Access Compliance Report

Public Rights-of-Way

(Curb Ramps)

Intersection ID: N/A	Main Street: WILTHSHIRE_MANOR_DR	Cross Street: LADBROKE_CT	Location: NW
ADA ID: E6993F2B1618	Ramp Type: Directional1	Initial Pass/Fail: Fail	Overall Compliance: No
		Severity Score: 1.25

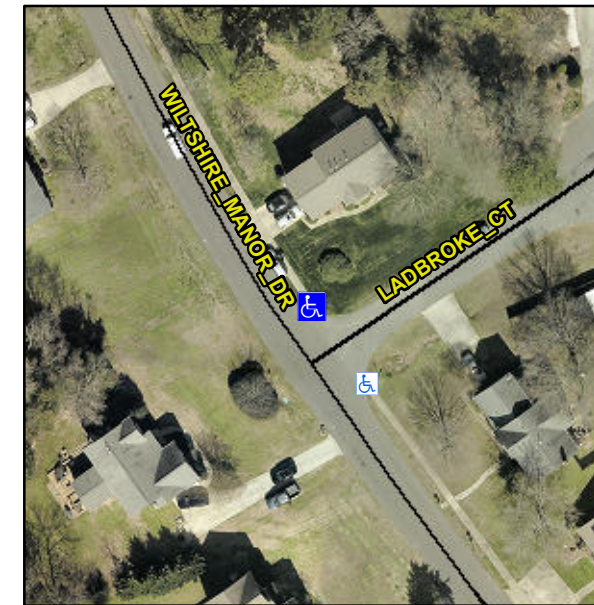
R304.5.3

Compliance	Description	Data	Compliance	Description	Data
N/A	Ramp Length (in)	49.0	N/A	Grade Break?	N/A
Yes	Ramp Width (in)	48.0	N/A	Grade Break Slope (%)	0.0
Yes	Ramp Slope (%)	0.6	N/A	Grade Break XSlope (%)	0.0
No	Ramp XSlope (%)	3.3			
N/A	Flare Type LT	N/A	N/A	Flare Type RT	N/A
N/A	Flare Slope LT (%)	N/A	N/A	Flare Slope RT (%)	0.0
N/A	Flare Traversable LT?	N/A	N/A	Flare Traversable RT?	N/A
N/A	Landing Length (in)	0.0	N/A	DWS Provided?	N/A
N/A	Landing Width (in)	0.0	N/A	DWS Contrast?	N/A
N/A	Landing Slope (%)	0.0	N/A	DWS Length (in)	N/A
N/A	Landing X Slope (%)	0.0	N/A	DWS Full Width?	N/A
N/A	Landing Curb? (Y/N)	N/A	N/A	DWS Offset LT (in)	N/A
N/A	Shared Landing?	N/A	N/A	DWS Offset RT (in)	N/A
N/A	Gutter Ponding?	0.0	N/A	Gutter Slope (%)	N/A
N/A	Gutter Lip Ht (in)	0.0	N/A	Gutter X Slope (%)	N/A
N/A	Painted X Walk1?	No		Road Slope (%)	1.6
	X Walk 1 Direction	To SE		Road X Slope (%)	2.1
	X Walk 1 Width (in)	N/A		Clear Space?	N/A

Remove & Replace Entire Ramp.
